TCG121WX Series Package Change Notification

Please accept this letter as an official notification of the packaging change of TCG121WX series due to paper gasket reduction. Only TCG121WX series will be affected by this notification.

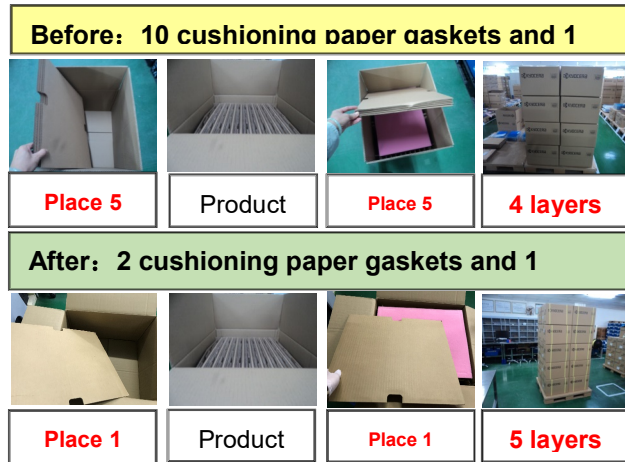
The number of paper gaskets change from 10 pieces to 2 pieces per box.

The height of each box is changed from 331mm to 290mm, other dimensions remain unchanged.

The quantity in each box remains unchanged.
